TMDXEVM6472
Engineering Change Order (ECO)
About RGMII-ID setting of ETH PHY
For PCA REV: 18-00065-01 & 18-00065-02 ONLY
11-JANUARY-2010

Figure: Position of R52 and R53 – at bottom side of PCB

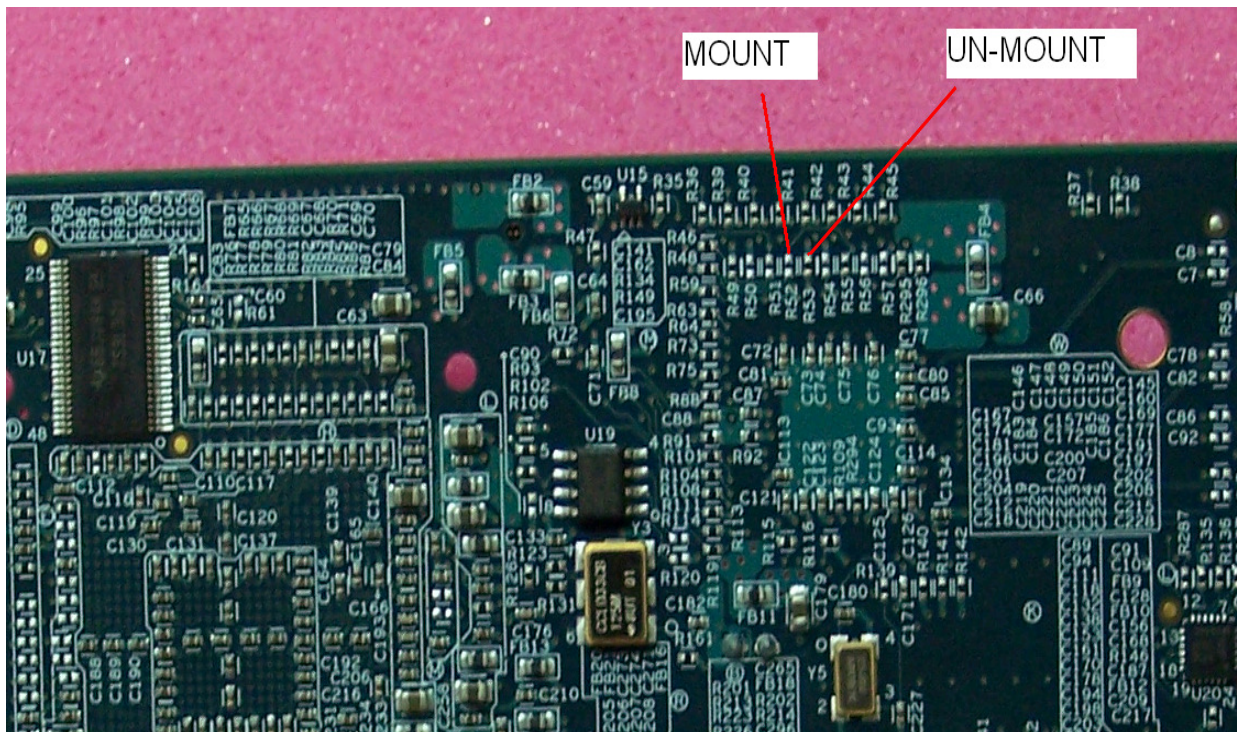
Above versions of board design contains Marvell #88E1121 ethernet PHY (U2). The default board configuration for 88E1121 sets RGMII-Internal Delay timing using CONFIG[3] pin of 88E1121 as “11” meaning both RGMII TX and RX clocks are internally delayed by 88E1121.

This setting may work well for 10/100 Mbps data-rate but it could have an un-reliable RGMII timing when PHY is operated for the data rate of 1000 Mbps. The impact could be an increase in failure rate of ethernet packet delivery at 1000 Mbps data-rate. This could also impact the EMAC boot of C6472 as during network boot-up RGMII EMAC of C6472 operates at 1000 Mbps data-rate.

The better RGMII-ID setting at CONFIG[3] pin of 88E1121 should be “01” meaning RGMII TX clock is NOT internally delayed and RGMII RX clock is internally delayed.

Above change can be done by simply changing the assembly of 0E resistors R52 and R53. Resistor R52 should be **mounted(0E)** and resistor R53 should be **un-mounted**.
